PAINT MINE ID TEAM

Subject: Sunshine Quartz/Hematite Claims Project – Exploration and Development,
Data/Information Needs for the Environmental Analysis and Evaluation Process

We are underway with the environmental analysis and evaluation of the subject project. Additional data and information are needed to meet the requirements of the National Environmental Policy Act (NEPA) and associated Forest Service direction, in regards to: public scoping, purpose and need, reasonable range of alternatives, reasonable foreseeable actions, connected actions, and cumulative affects. We also need clarification of existing data and information provided to us in recent months.

**Revised Test Pit Configuration
Staged Excavation
Overburden Removal**

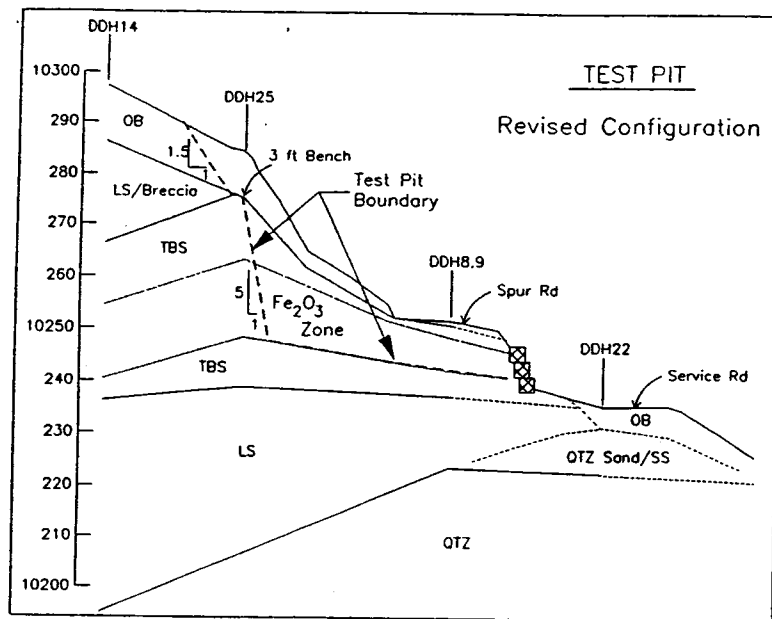
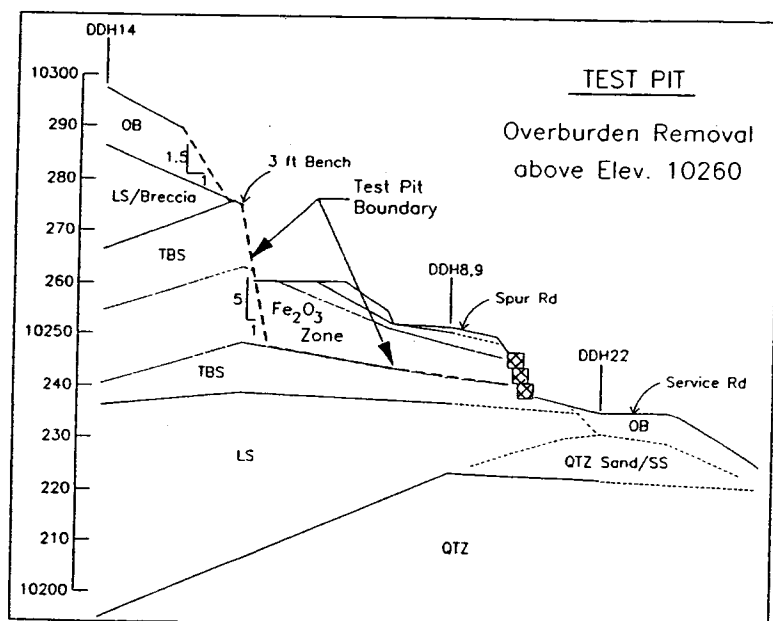
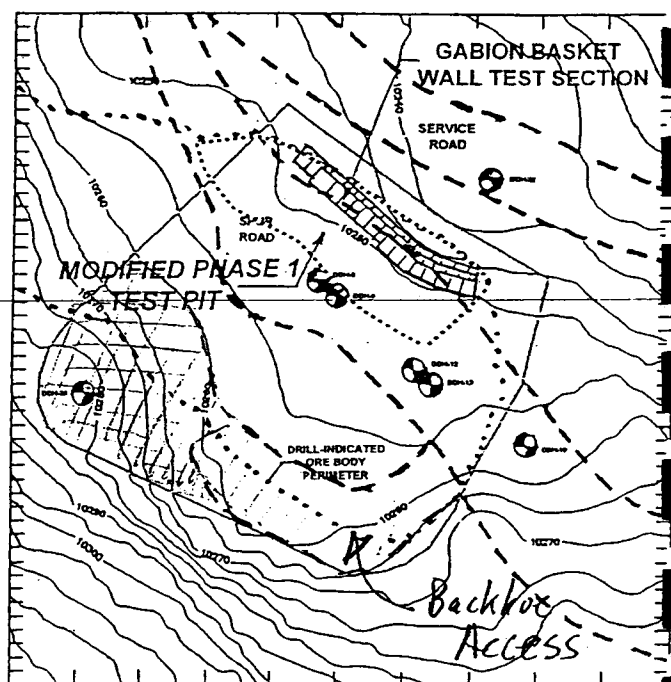
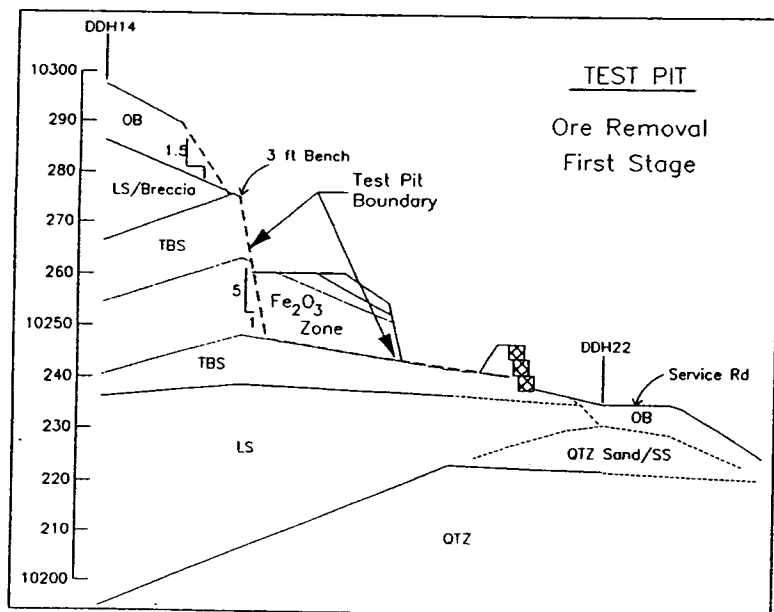
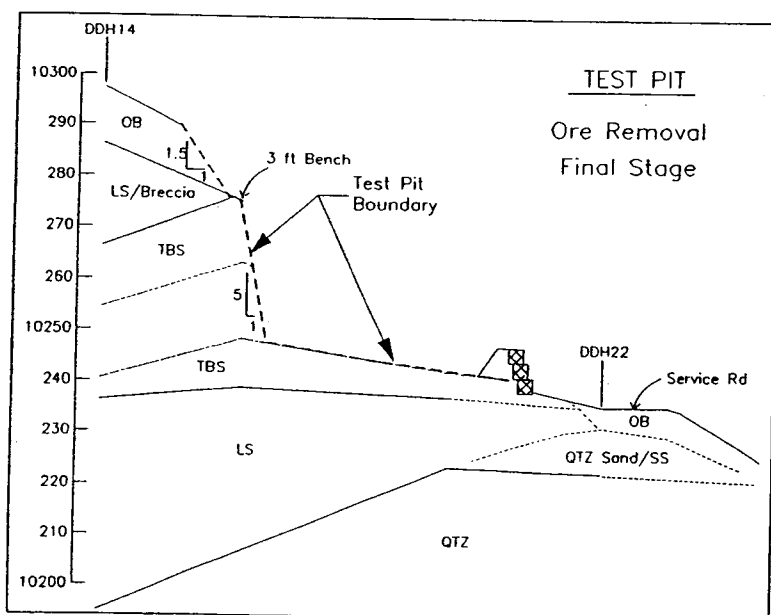
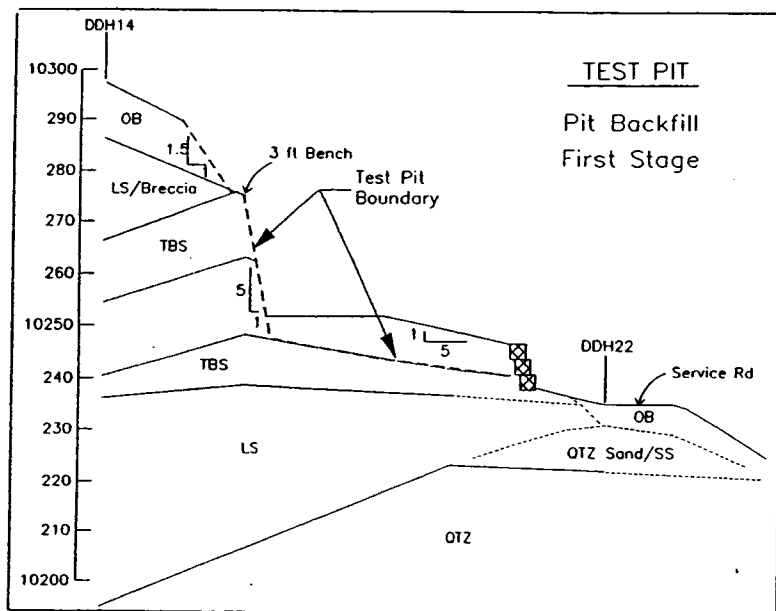
Question No. 3: *"How will the mine operator insure the safety of workers operating heavy equipment below a 50 foot high slope that is prone to raveling and rock spalling? What is the overall slope stability of this temporary construction slope, including the stability of the overburden and wet draw? Will the back slope be benched or scaled to assure stability and safe working conditions?"*

Per this analysis, the temporary embankment has been modified to provide a more stable and safe configuration. The pit depth has been decreased to allow for a bench at the top of the rock/soil interface. In addition, 12 to 15 feet of cut have been added to flatten the cut slope on the unconsolidated overburden at the top of the slope. Finally, by following the ore body and not overexcavating within the pit, the steep rock slope face will only be a maximum of 30 feet.

In terms of Item No. 3, overall slope stability analyses before and after pit excavation and reclamation are included in the attachments. In summary, the existing undisturbed slope has a stability safety factor of 2.33 for deep-seated failure and 1.11 for localized surface failure of saturated unconsolidated overburden. Upon completion of all gabion walls, the disturbed embankment overall and local safety factors are both on the order of 1.5. Because of this analysis, the gabion base design for the upper levels was modified to improve overall stability of the embankment from failure.

Sample Ore Transport Route Map

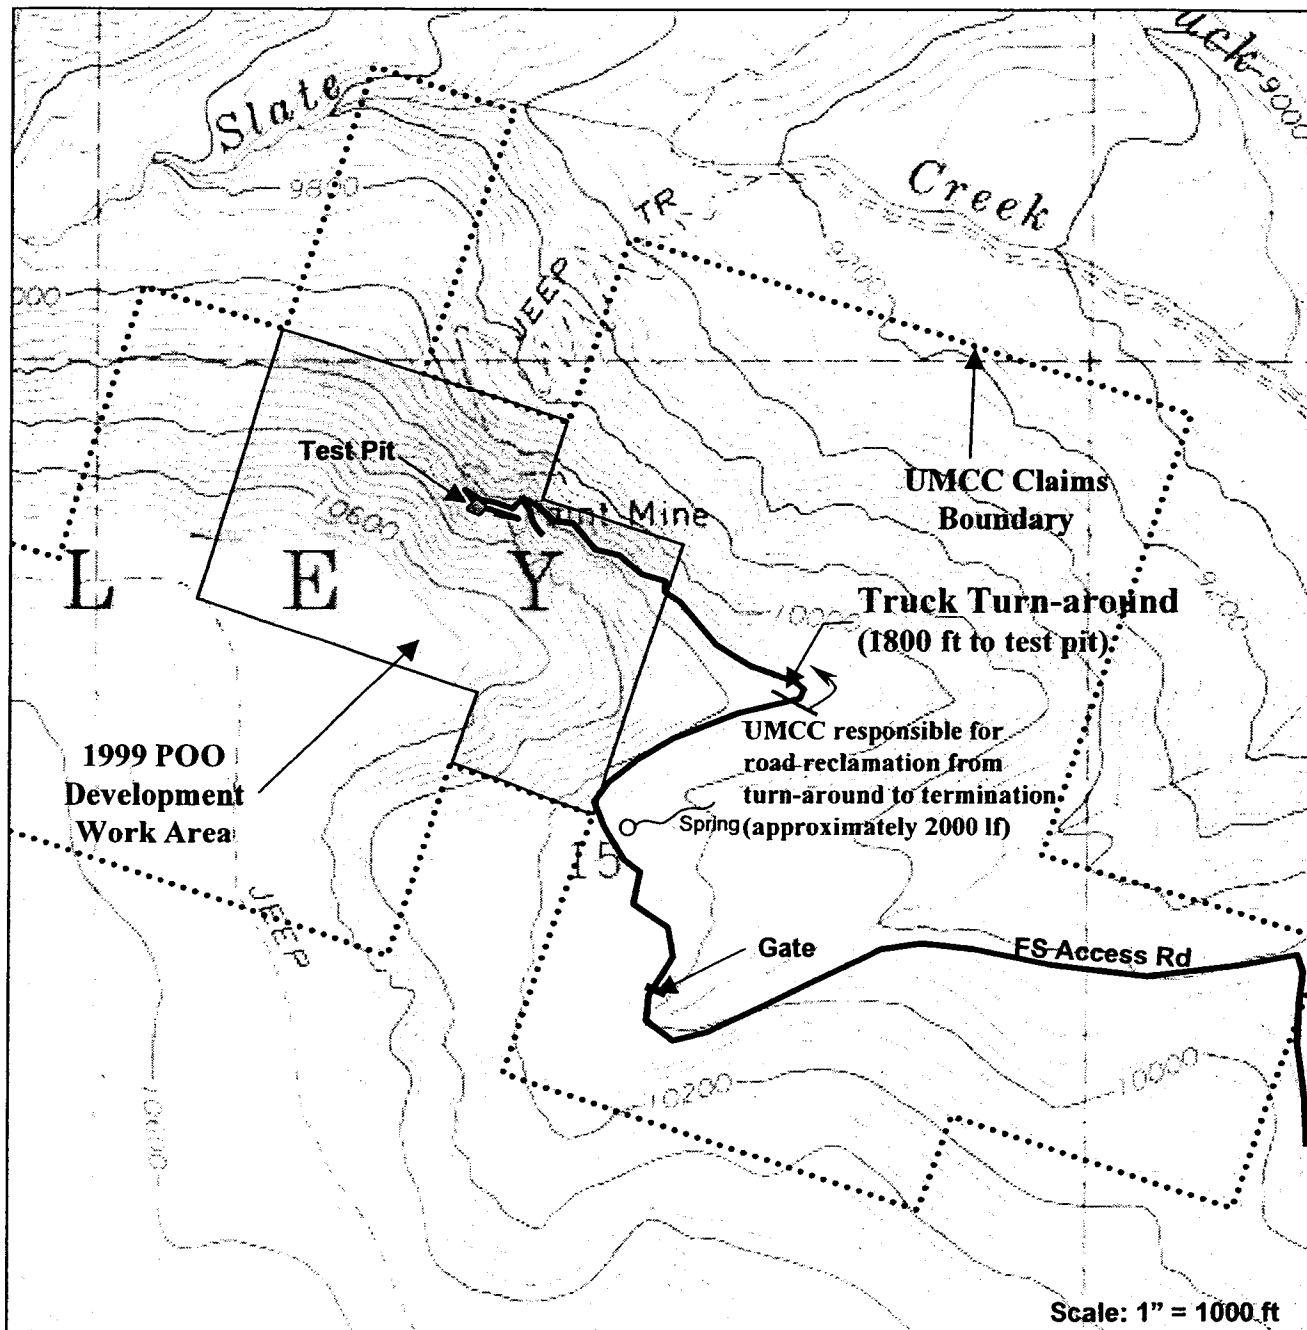
The revised Plan of Operations will need to describe the system that will be used to transport ore from the mine site to the “turn-around area”. The following items need clarification:

- ✓ We understand that ore will be transported by 5-ton trucks to the turn-around area. Please confirm this in a revised Plan of Operations. The “Supplemental Discussion to 1999 Plan of Operations”, and Uintah Mountain Cooper Company’s letter to Utah Division of Oil, Gas and Mining have conflicting statements regarding this matter.
- ✓ Verify the actual location of the turn-around area, i.e., 600 feet or 1800 feet from the mine site. If this location is mapped, please provide a copy of the map.
- ✓ Describe how ore will be transferred from the 5-ton trucks to the 10-wheel trucks at the turn-around area, i.e., front-end loader or conveyor.

Turn-around area: A minor change is needed in the first paragraph of Section E of the "Supplemental Discussion" to reflect the changes mutually agreed to by UMCC and the Forest Service that occurred after issuing the 1999 POO in September 1999. Item 3 on page 2 of the letter to the Utah Division of Oil, Gas and Mining accurately describes the truck turn-around location. Ore will be transferred from 5 to 12 ton trucks via portable bin with conveyor or by backhoe – both methods are planned to be evaluated as part of the testing program.

Camp/Transfer Site

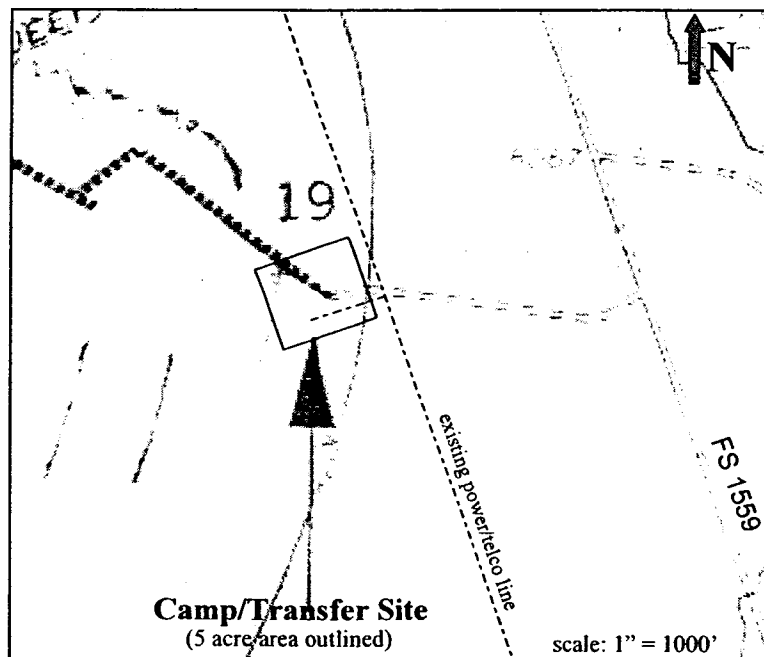
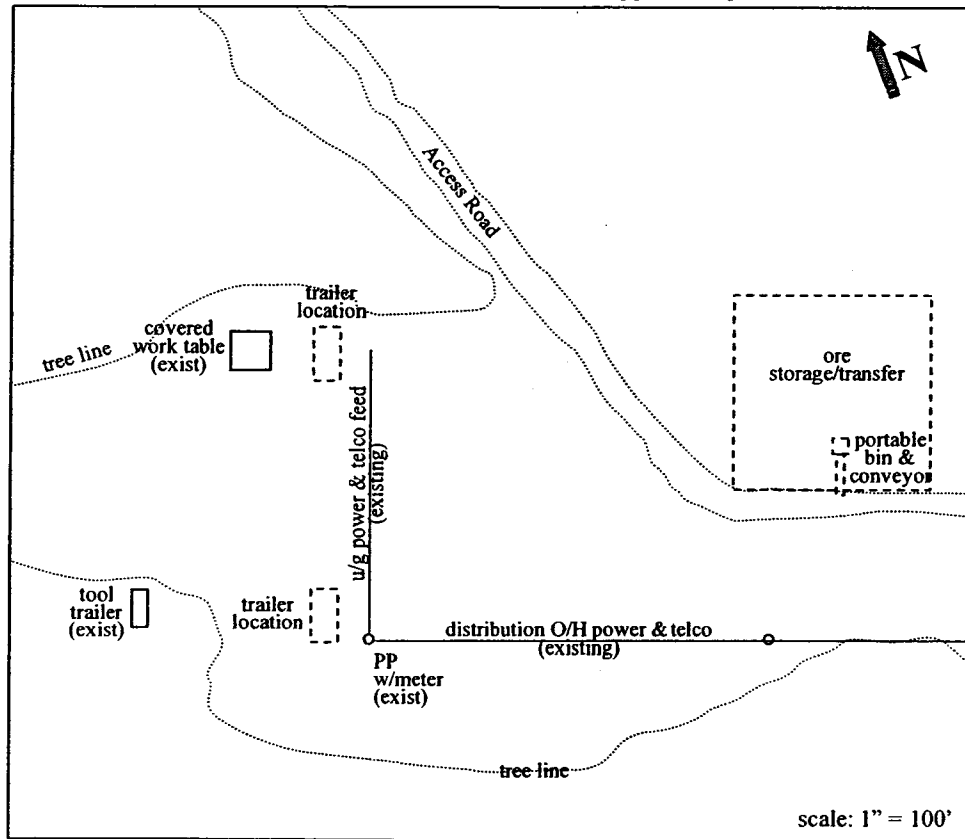
The revised Plan of Operations must include a description and map of the “camp area”. Each temporary facility and piece of equipment should be briefly described. The map should show the location of proposed facilities and equipment to be used in the mining operation, i.e., temporary quarters, sanitation facility, fuel site, ore transfer site (bins, conveyors), etc.

Ore transfer at camp site will be done by use of temporary bins and conveyors. Power for transfer equipment will be either through use of existing distribution lines near the camp or by gas-operated engines. All sample ore will be removed from the forest. No milling facility or support facilities are needed or are planned within the National Forest (UMCC has recently obtained a mill site near Price, Utah). A copy of the Plan of Operations is available at District office.

(note: structure locations have not been surveyed in and are shown as approximate
(dashed lines denote future facilities to support test pit work))

STANDARD DETAIL FOR WATER BAR

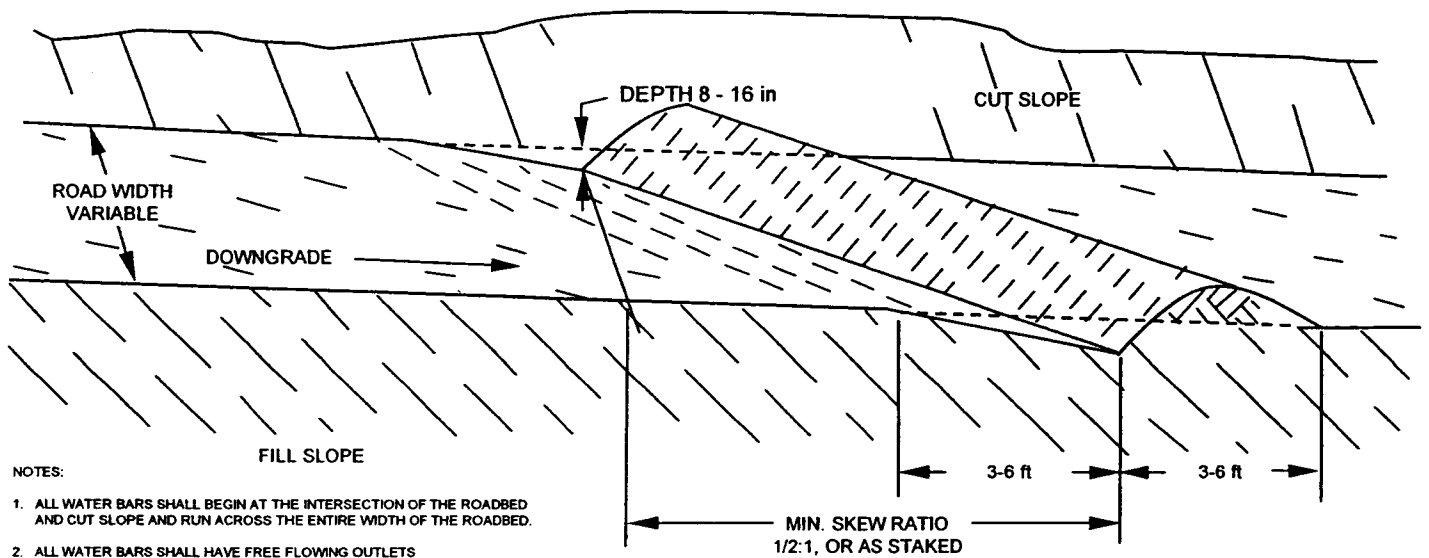
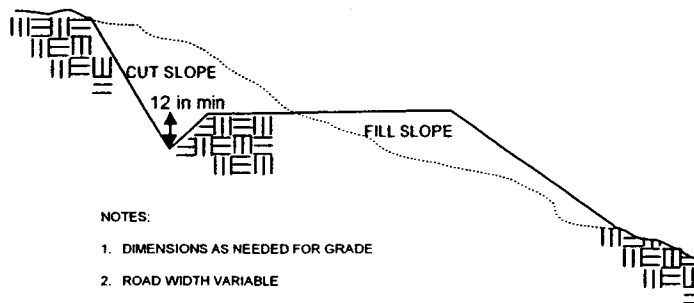
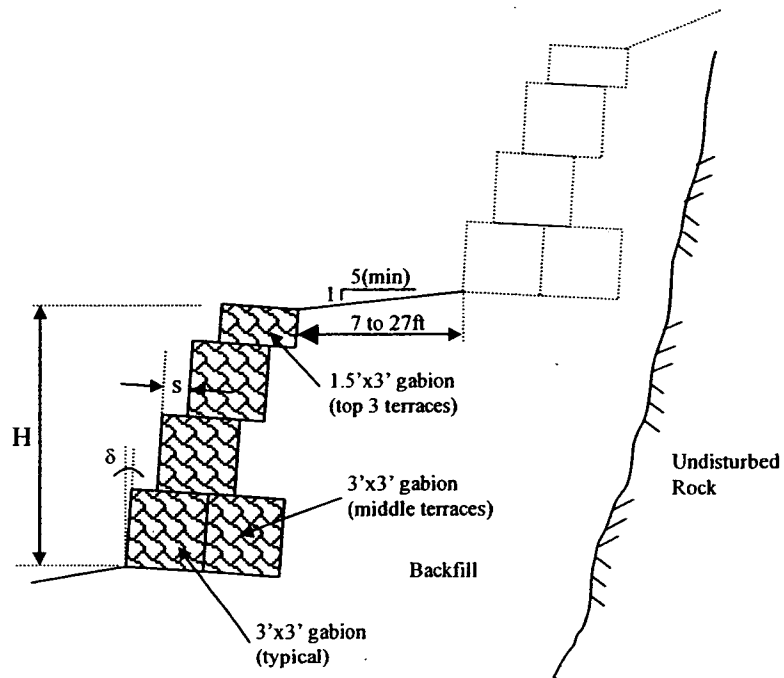
The environmental document will include a section on the method and procedure to channel and control runoff from the access road, disturbed slopes, and spur roads within the mine site. Our field investigations indicate that runoff must be impeded, and then channeled to selected locations for downslope dispersal. If Uintah Mountain Copper Company has developed a method and procedure for this issue and management concern, please include them in a revised Plan of Operations. Otherwise, the Forest Interdisciplinary Team will develop it as part of the mitigation section of the environmental document.

In terms of the historic approach to road drainage/erosion control, the Forest Service has required construction of water bars and road edge bar ditches to periodically channel and remove drainage to the outside (downhill) edges of the road. This has been highly successful in controlling runoff and stormwater. The concept is discussed in detail in the Supplemental Discussion, Section H, first paragraph. A typical cross section is attached.

In terms of the test pit disturbed slope, temporary drainage control during excavation and reclamation is discussed in the Supplemental Discussion, Section H, third paragraph. A typical detail is attached for further clarity. The test pit is adjacent to an existing natural erosive talus slope and slide zone. Storm water and runoff will be inhibited by placing the terraced gabion rock wall as the reclamation method. See the analysis in the Supplemental Discussion, Section H and the associated sedimentation calculations previously provided to the Forest Service.
